Appendix G

Assessment of the refinements to the
project

G1 Description of proposed refinements

Figure G.2 Mt Tomah, Mt Wilson and Mt Irvine refined preliminary flight path

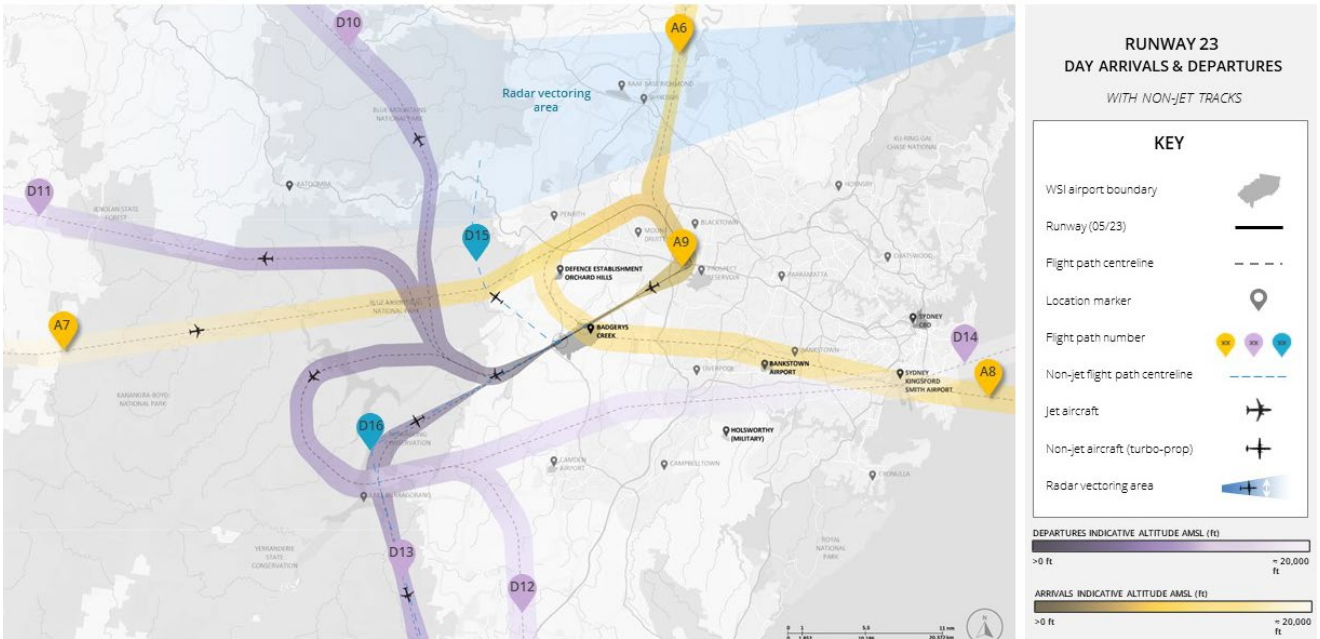
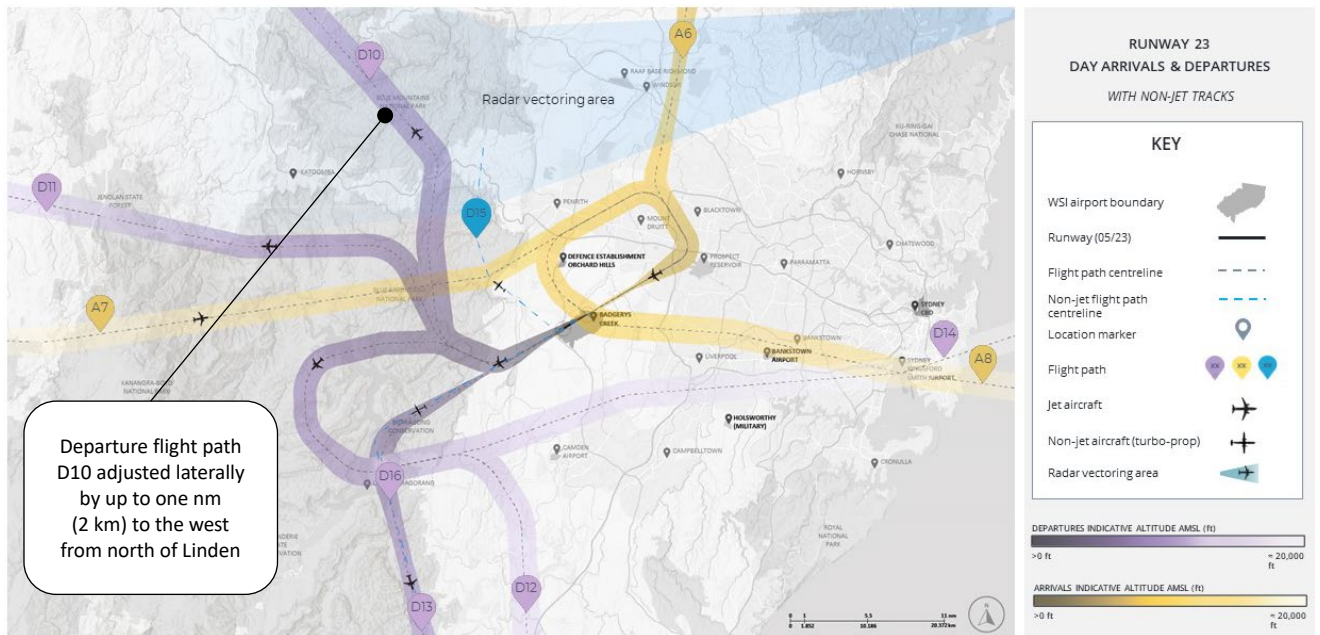
The proposed change would realign a section of the daytime northern jet departures preliminary flight path Runway 23 Departure North Day (preliminary flight path D10) further away from the Mt Tomah, Mt Wilson and Mt Irvine areas. The new alignment would be located to the south and west of the preliminary flight path presented in the Draft EIS and, at the widest point of realignment, be up to around one nm (2 km) further west than the preliminary flight path presented in the Draft EIS.

The realignment would commence from a point over one nm (around 2.5 km) north of Linden (where flights would be at an altitude of around 11,000 ft (3.4 km)) and merge back to the preliminary flight path generally to the east of Lidsdale at around 18,000 ft (5.5 km) (refer to Figure G.1 (Draft EIS) and Figure G.2 (refined flight path)).

- move the Runway 23 northern jet departures preliminary flight path approximately one nm (2 km) further away from Mt Tomah and 0.9 nm (1.8 km) from Mt Wilson/Mt Irvine residential areas, therefore providing additional lateral distance between the preliminary flight path and these communities
- change the location of the preliminary flight path to provide additional lateral separation between the preliminary flight path and the Emu Cave Aboriginal Place site
- not increase the required fuel burn from aircraft (due to increased flight length) or reduce airport efficiency compared to the preliminary flight path presented in the Draft EIS.

Figure G.4 Required Navigation Performance – Approval Required approach removal

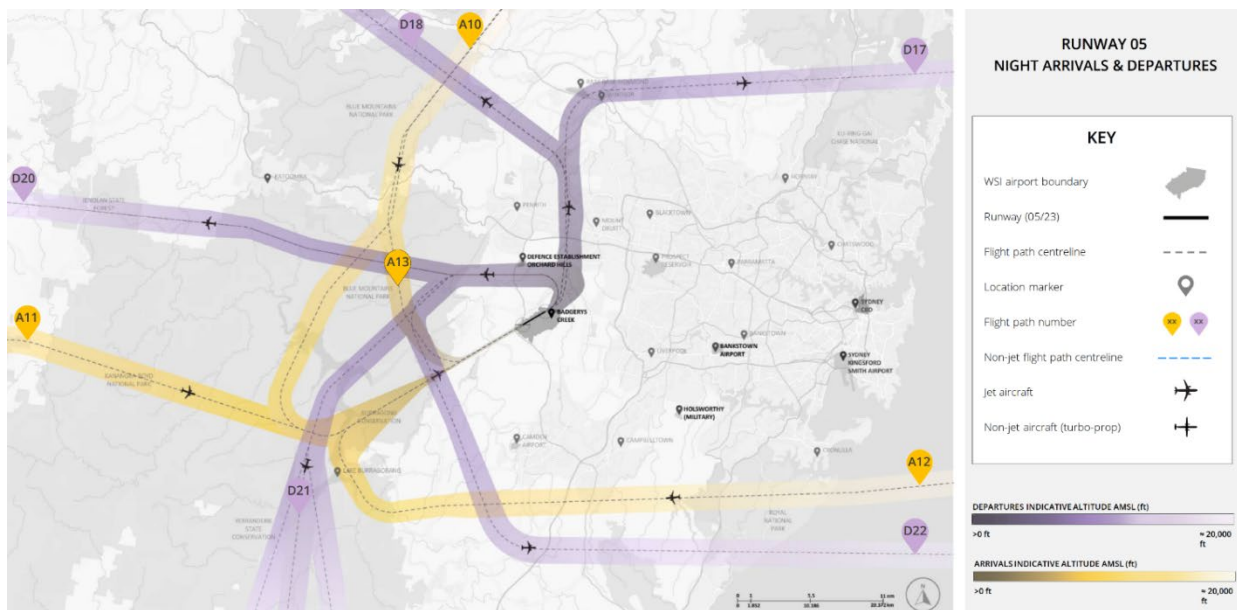
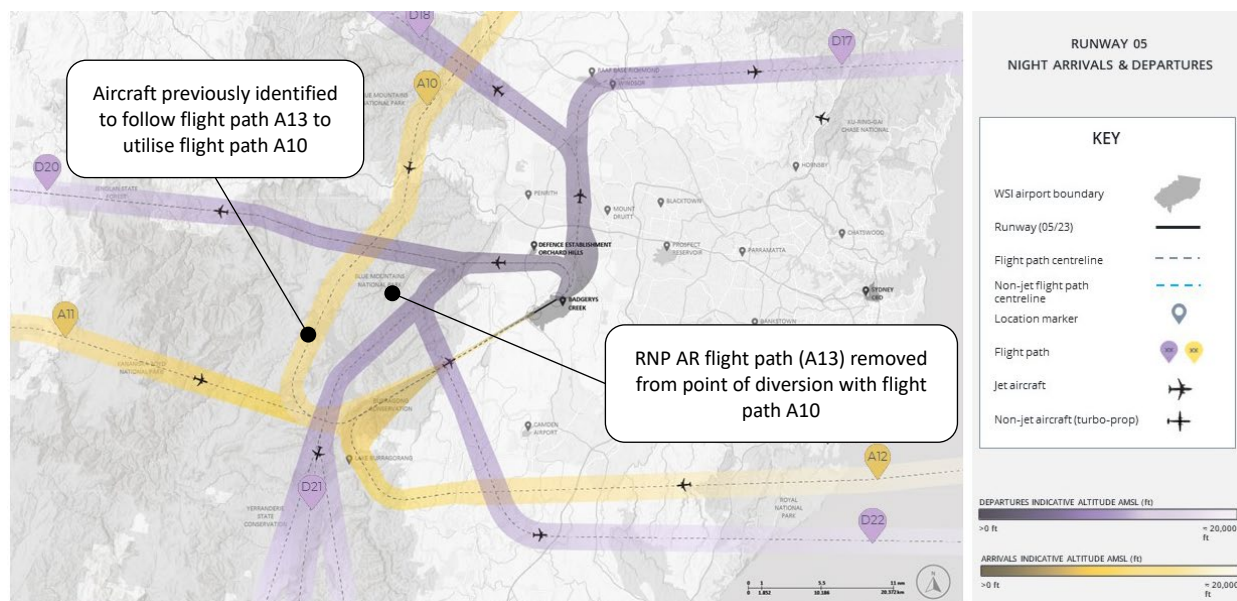
The proposed change would remove the Required Navigation Performance – Approval Required (RNP AR) preliminary flight path (Runway 05 Arrival (RNP) North Night – preliminary flight path A13) identified in the Draft EIS during night time periods (refer to Figure G.3). Flights approaching WSI would instead utilise the alternative preliminary flight path A10 (refer to Figure G.4) as presented in the EIS.

Removal of the RNP AR approach flight path at night would result in an increase in the altitude of aircraft which fly over the residential areas on this approach. In particular, removal of the RNP AR approach flight path and use of the Runway 05 Arrival North Night flight path (preliminary flight path A10) would result in all aircraft on this approach path flying over Linden and Woodford at a height of around 12,000 ft (3.7 km) rather than around 5,000 ft (1.5 km), which would occur on the proposed RNP AR approach flight path as described in the Draft EIS.

- result in a measurable noise benefit to the communities of Linden and Falconbridge when RNP AR capable aircraft are approaching Runway 05 at night
- allow aircraft passing over the Linden observatory to pass this location at a higher altitude, reducing the extent of visual intrusion to this site
- result in reallocation of aircraft to preliminary flight path A10, resulting in a minor increase in fuel burn for RNP AR capable aircraft at night.

Figure G.6 RRO night approach to Runway 05 refined preliminary flight path

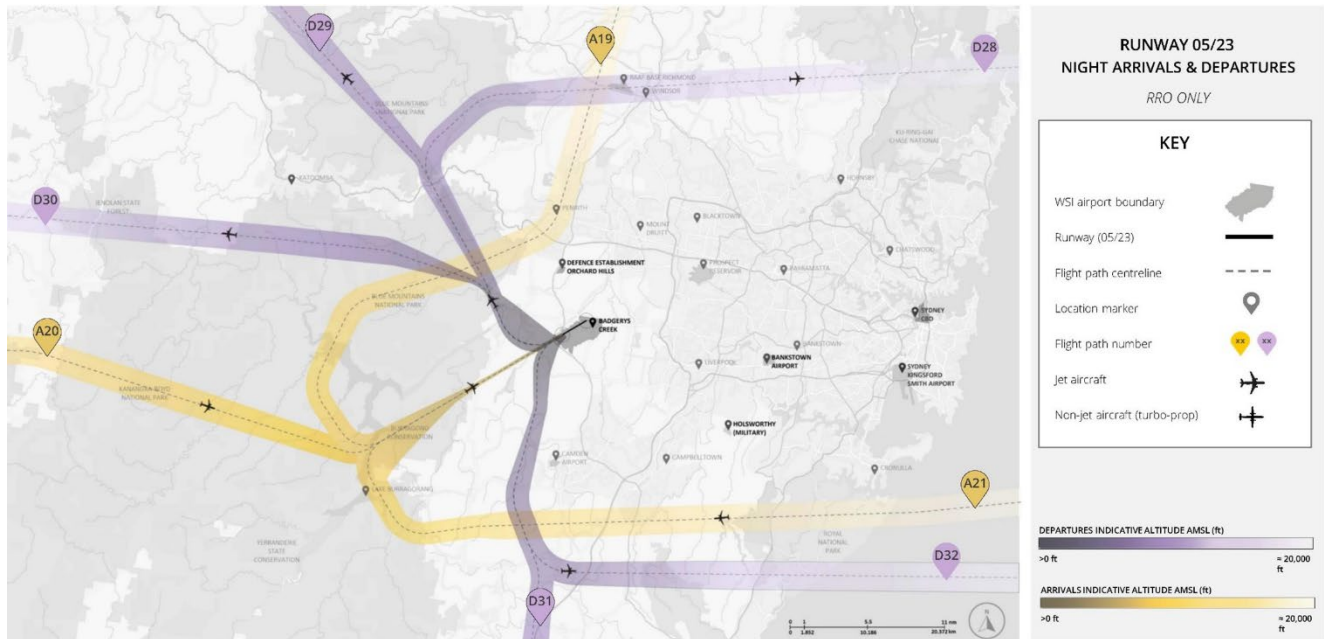
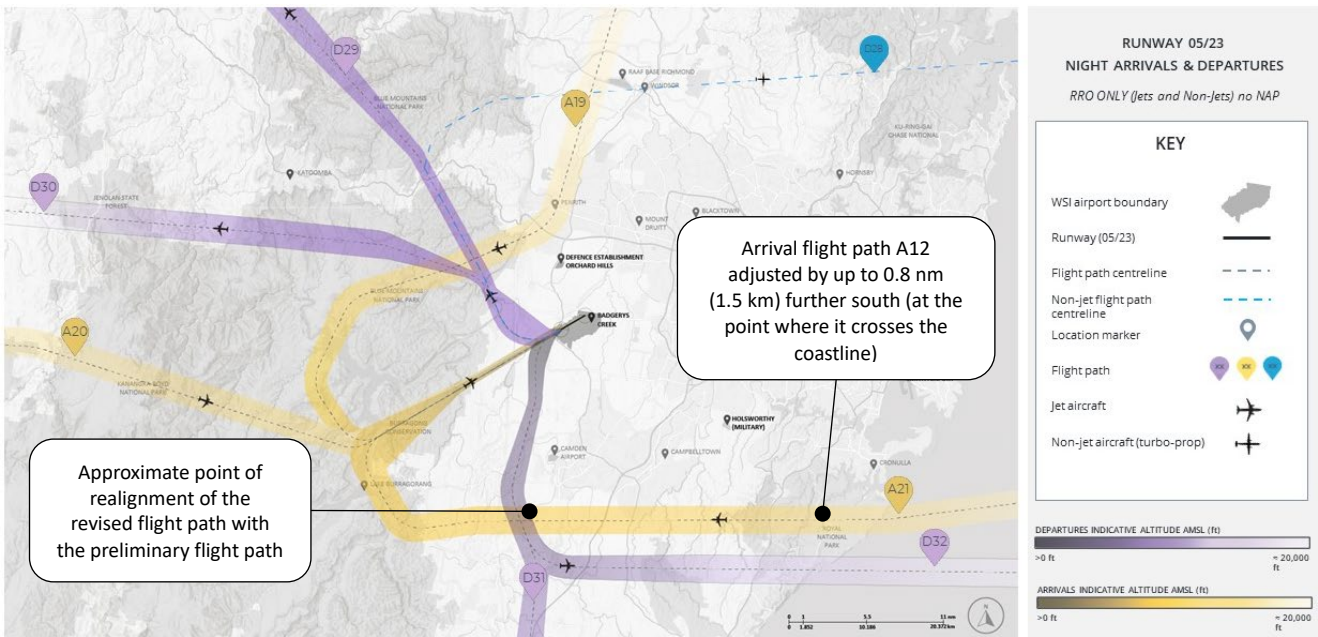
The proposed change would move the Runway 05 Arrival East Night flight path (preliminary flight path A21) that approaches WSI from the east around 0.8 nm (1.5 km) further south at the point where it crosses the coastline south of Bundeena. Arriving aircraft at the point south of Bundeena would be at an altitude around 15,000 ft (4.5 km) (refer to Figure G.5 (Draft EIS) and Figure G.6 (refined flight path)).

The revised flight path would continue to provide separation between the arrival (A21) and departure (D22) preliminary flight paths. The realigned preliminary flight path would merge with the preliminary flight path at a point near the suburb of Mount Hunter (at an altitude of around 9,000 ft (2.7 km)). From this point, the revised flight path would continue to WSI along the same flight path alignment as presented in the Draft EIS (A21).

The proposed refinement to the flight path would result in a series of benefits compared to the preliminary flight path presented in the Draft EIS. The proposed refinement would reduce the level of direct community overflight to communities such as Bundeena.

Figure G.8 Refined RRO runway mode of operation flight paths, RRO-NAP and proposed radar vectoring area

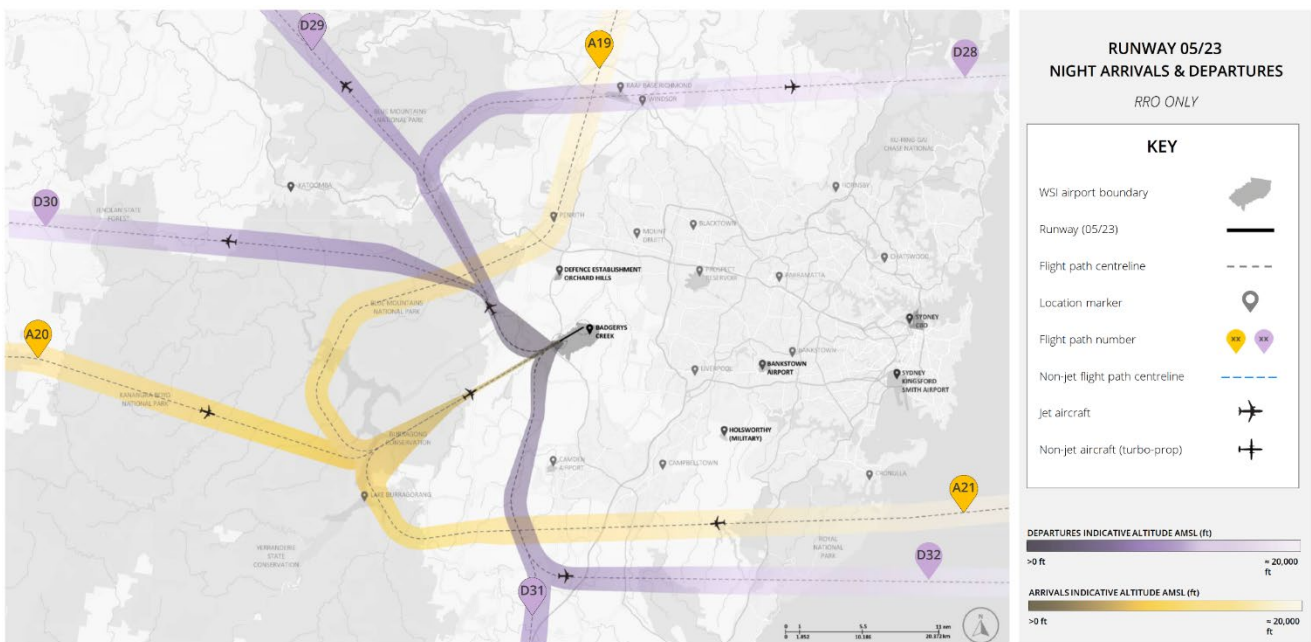
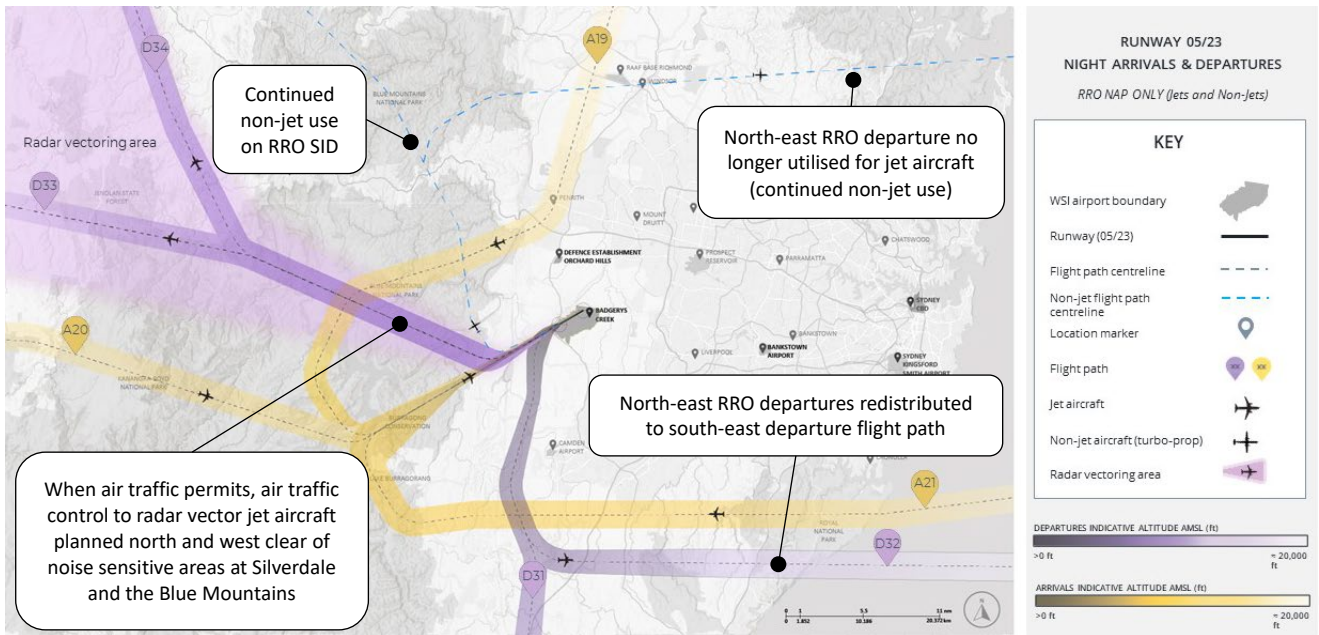
This change would discontinue use of the Runway 23 Departure Northeast Night (RRO) flight path (preliminary flight path D28) for jet aircraft. All jet traffic previously assigned jet aircraft along the Runway 23 Departure Northeast Night (RRO) flight path would be redistributed to the Runway 23 Departure Southeast Night (RRO) (preliminary flight path D32). The reassigned traffic includes all eastern departures to destinations in New Zealand, Pacific Island countries and the USA.

The change to the Runway 23 Departure Northeast Night (RRO) preliminary flight path would not affect non-jet aircraft which would continue to use this flight path (refer to Figure G.8).

This change would include the introduction of a new night-time (11 pm to 5:30 am) RRO noise abatement procedure (RRO-NAP). Under the proposed new RRO-NAP, northbound and westbound departure aircraft will maintain the Runway 23 straight ahead runway heading (230 degrees) flight path for approximately 5 nm (9.3 km) rather than immediately turning as soon as safely possible. This would result in avoiding overflights of communities as much as possible, including Wallacia and Mulgoa. However, the RRO-NAP would result in additional overflight of parts of Silverdale and Warragamba.

The flight paths depicted are indicative. Air traffic control will radar vector aircraft along paths similar to these tracks as indicated by the shaded area in Figure G.8.

Figure G.11 Differential contours – N60 Night (11 pm to 5.30 am) – 2055

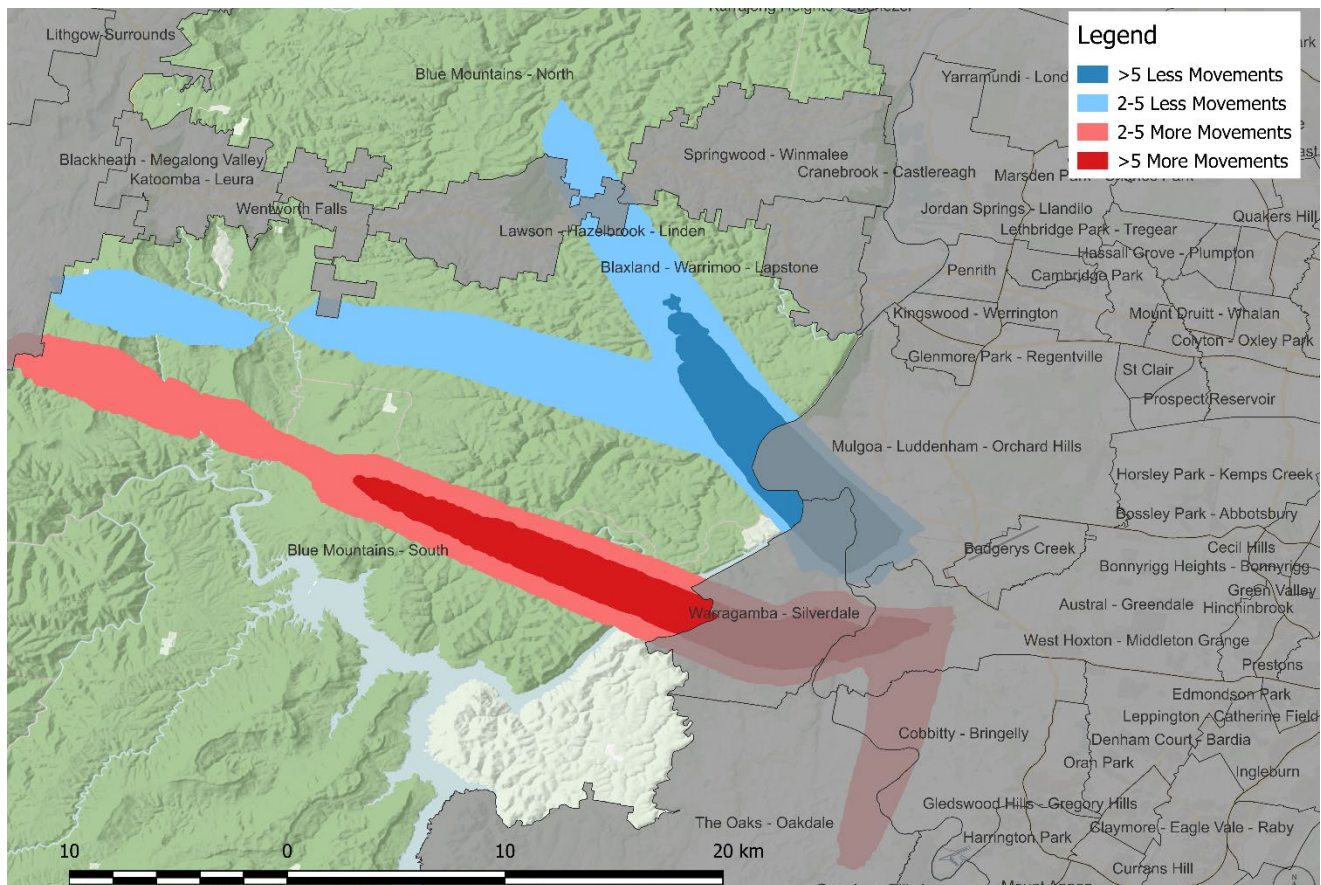
The changes proposed in the RRO flight paths have potential to generate the previously identified noise impacts on the GBMA. The proposed changes redistribute a portion of the traffic further south over a different region of the GBMA. The shift in the aircraft producing at least 60 dB(A) is shown in Figure G.11. As presented in Figure G.11, blue shaded areas are anticipated to result in at least 2 less movement whereas red areas are anticipated to result in at least 2 additional movements of at least 60 dB(A) compared to the assessment presented in the Draft EIS. The selection of 2 movements is based on a likely threshold of noticeability in the number of aircraft overflights.
